PLANNING COMMISSION STAFF REPORT

WOODBRIDGE PACIFIC GROUP ON BEHALF OF PALM CANYON 65, LLC FOR THE DEMOLITION OF AN EXISTING COMMERCIAL SITE TO CONSTRUCT A MIXED-USE PROJECT ON 12.4-ACRES CONSISTING OF (60) SINGLE-FAMILY RESIDENCES ON LOTS AVERAGING 5,136-SQUARE FEET IN SIZE, (20) MULTI-FAMILY RESIDENTIAL CONDOMINIUMS AND APPROXIMATELY 17,872-SQUARE FEET OF COMMERCIAL SPACE LOCATED AT 777 SOUTH PALM CANYON DRIVE (CASE NOS. 5.1378 PD-379, ZC 3.3876 MAJ AND TTM 36914).

Case 5.1378 PD-379 / ZC / 3.3876 MAJ / TTM 36914

ALTERNATE OPTION AT NORTH BOUNDARY

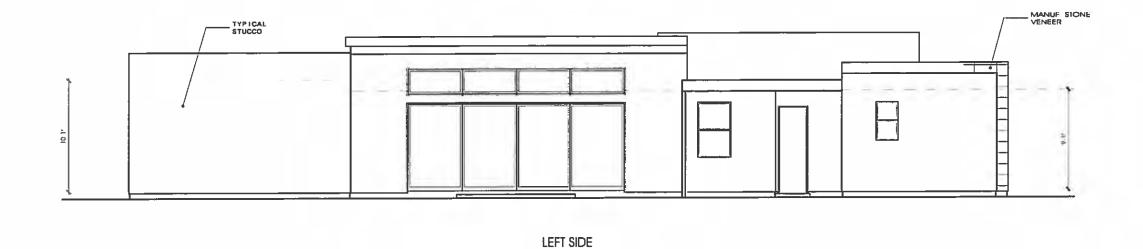
Member Hirschbein said the roof detail needs to be resolved (at the northeast corner); he prefers the 12' open-space with variation in material of continuous wall.

Member Purnel said it's desirable to have open-space at the north side and the wall is redundant.

Members Secoy-Jensen and Purnel said they are fine with capturing the open-space and it's a good trade-off.

- Northeast corner treatment is a continuation of the overhang on South Palm Canyon Drive.
- Option A is used to provide 12' of open-space at the north property line (no private patios).
- One gate on Belardo (instead of 2 vehicular gates).
- North wall include some variation in material.
